FINAL SITE 17 WORK PLAN TO INVESTIGATE AND REMOVE RELOCATED SOILS WITH  
TRANSMITTAL LETTER NAS BRUNSWICK ME

10/3/2008

ECC

DATE: 3 OCTOBER 2008	JOB NO.: 5700.017
ATTENTION: Todd Bober, RPM and Paul Burgio, BEC	
RE: Final Site 17 Work Plan to Investigate and Remove Relocated Soils	
Naval Air Station Brunswick, Maine

**Figure 2**

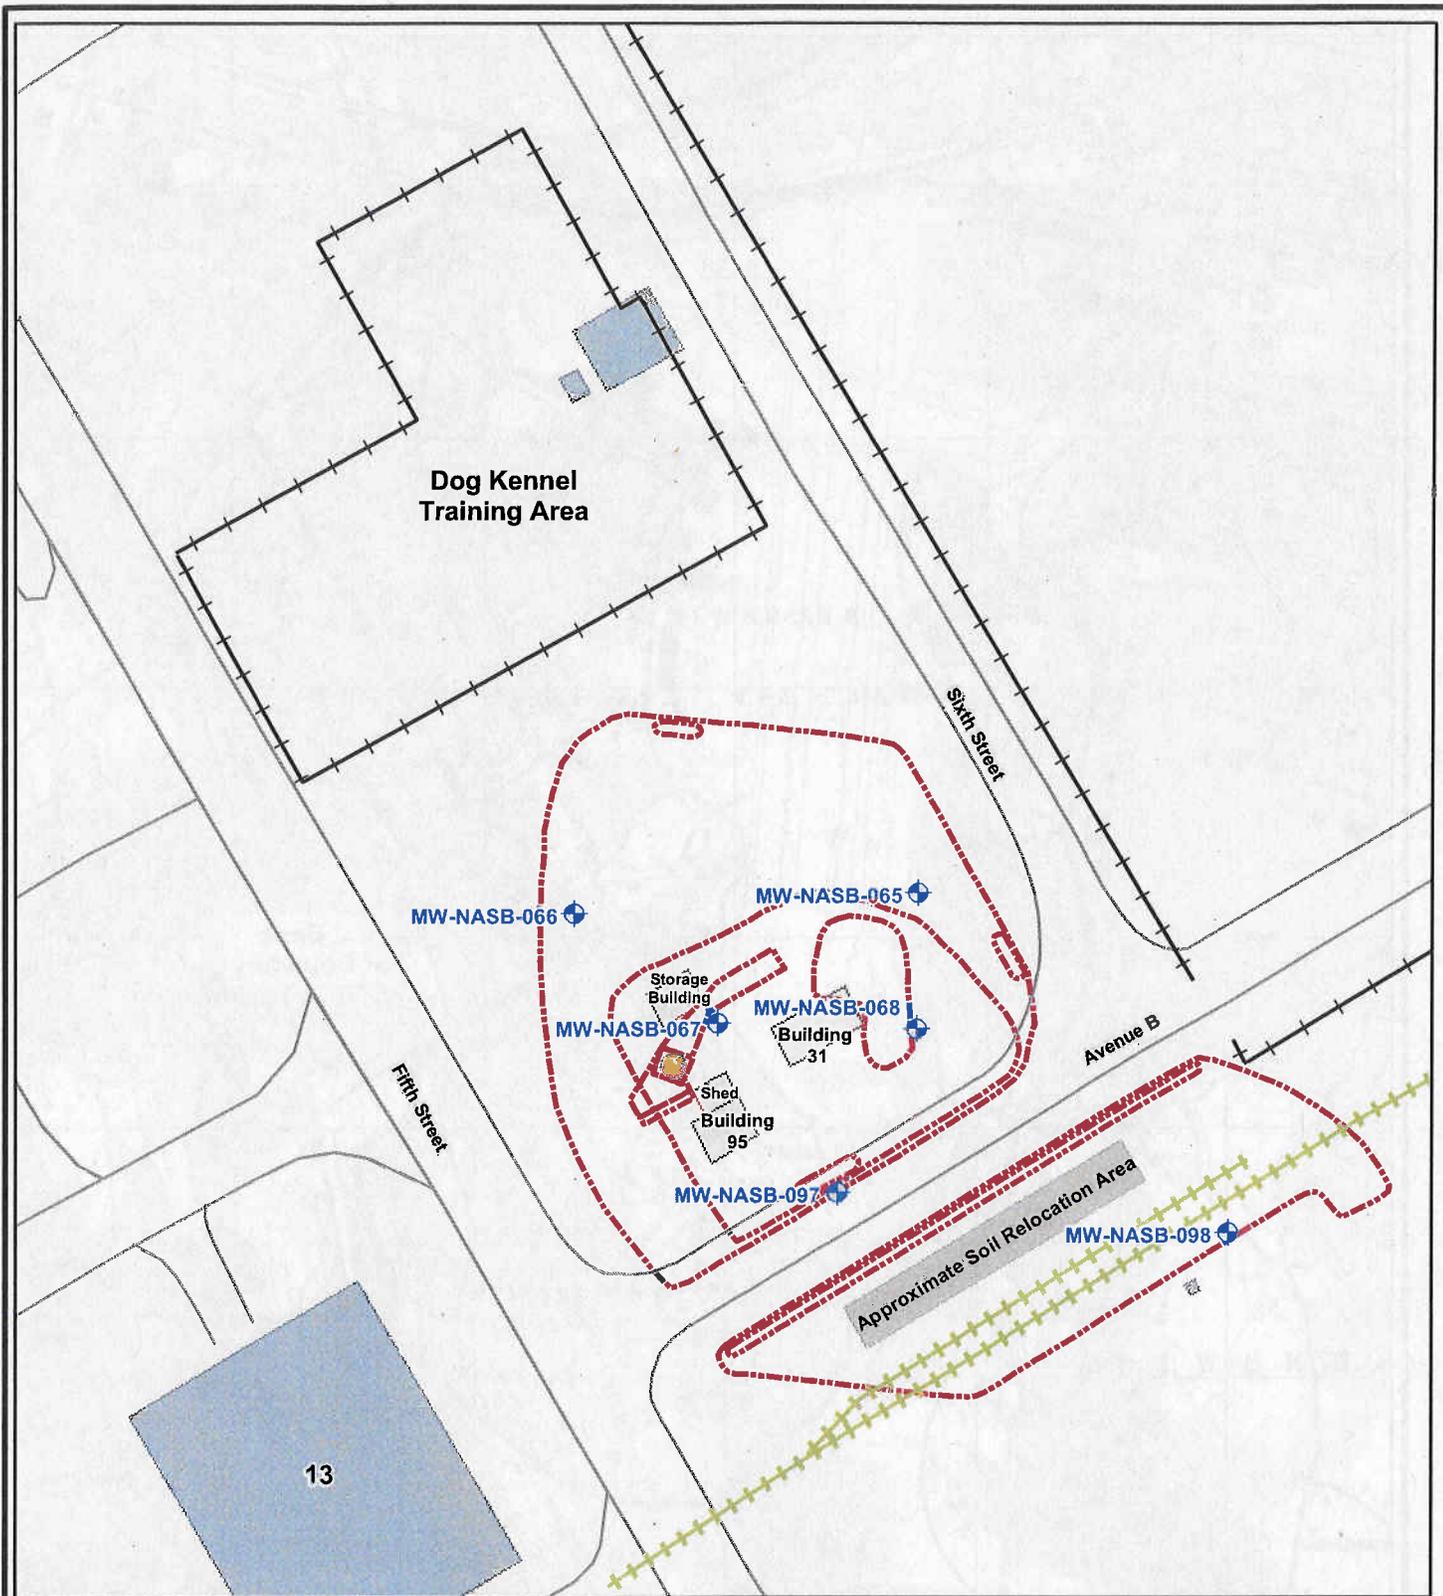
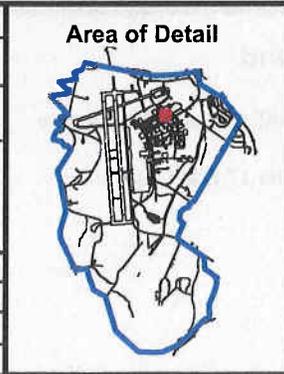
The southern boundary extends south of the former railroad tracks approximately 65 feet from Avenue B, as shown on figure 2 in this workplan. Please revise.

It is unclear to MEDEP exactly what is intended but there must a limit to disturbing the site if the relocated soil is not readily distinguishable. Please add the following language: "It is anticipated that no more than 3 test pits will dug perpendicular from Avenue B to intersect the reported burial location as identified in the Draft Final Closure Report." Also please revise figure 2 to show the approximate locations of the proposed test pits.

<p>ABB Environmental Services Inc. ASEA BROWN BOVERI</p>	<p>CONTAMINANT SUMMARY AT 3 FT.</p> <p><i>ACTION MEMO</i></p>	
	<p>BUILDING 95 EE/CA</p>	
<p>INSTALLATION RESTORATION PROGRAM NAVAL AIR STATION BRUNSWICK, MAINE</p>	<p>7122-02</p>	<p>FIGURE 1-13</p>

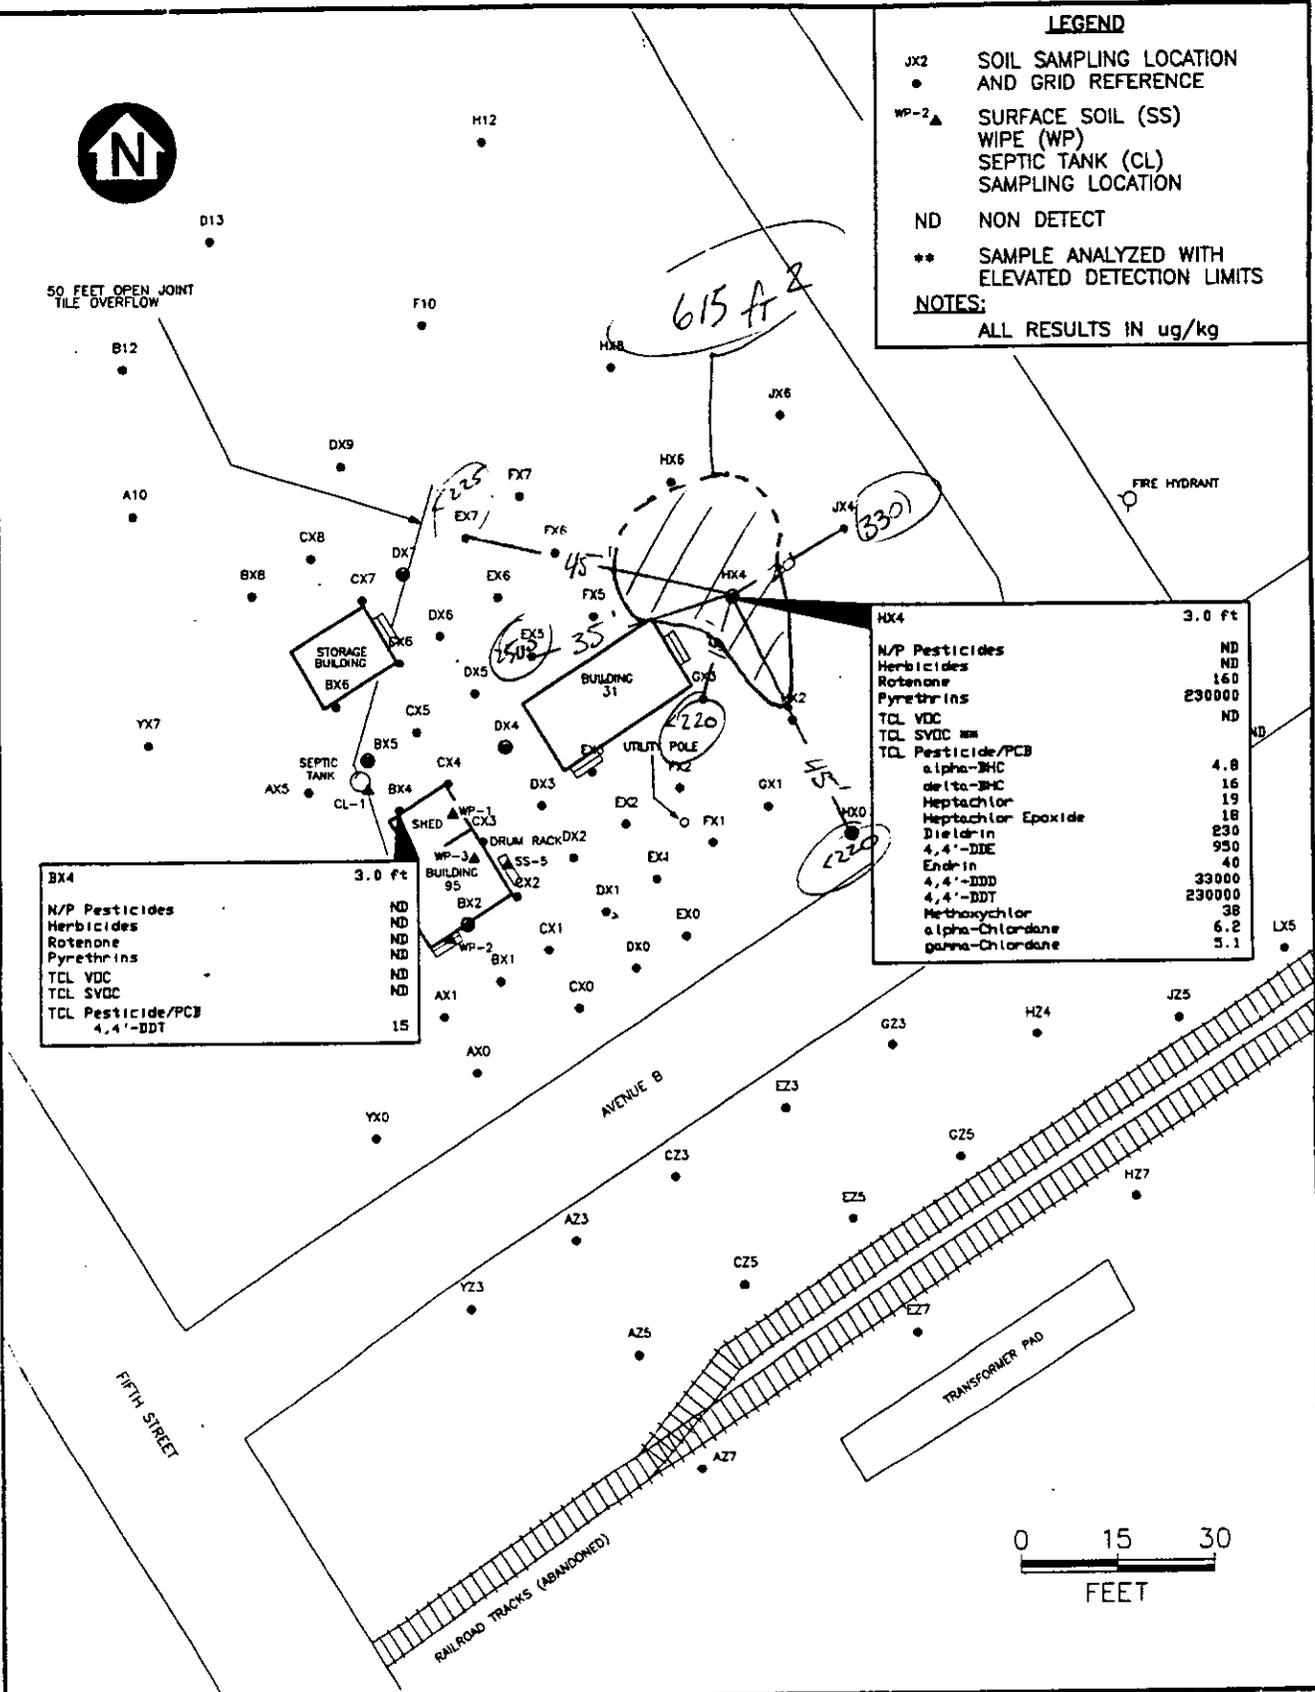
13. Comment (written): Page 2-54, Table 2-14: The table indicates that no subsurface soil concentration detected exceed the proposed subsurface soil PRG of 135,000 ppb. However, according to Figure 1-13, 230,000 ppb of DDT was detected at HX4 at a depth of 3 feet below ground surface. Therefore some subsurface soil will require excavation and incineration. This must be addressed in the Responsiveness Summary.

Response: As noted in the comment, 230,000  $\mu\text{g}/\text{kg}$  DDT was detected in subsurface soils at sampling location HX4. Therefore, Table 2-14 on page 2-54 should be modified to exclude the statement that "No subsurface DDT concentrations exceeded 135,000  $\mu\text{g}/\text{kg}$ ."

The additional soil volume to be excavated and incinerated is 45 cubic yards and is based on a surface area of 615 square feet and depth of 2 feet (see Appendix D). The additional costs for including this volume in the removal action is estimated using the same cost assumptions stated in the EE/CA and includes: \$1,500 for excavation, \$15,000 for transportation, and \$90,000 for incineration for a total additional cost of \$106,500. This represents a 3 percent increase in the original cost estimate of \$3,431,000. These revised costs are reflected in the cost estimates provided in Section C, "Description of Alternative Technologies" of the Action Memorandum.

OBJECTIVE: APPROXIMATE AREA FROM 2'-4' BGS IN VICINITY OF LOCATION HX4 (FIGURE 1-13 ATTACHED) THAT EXCEEDS PRGs OF 135,000 ug/kg DDT.

PERIMETER OF AREA IN RED : 615 FT<sup>2</sup>  
 DEPTH : 2 FT  
 1230 FT<sup>3</sup> ~ 45.6 CUBIC YARDS.
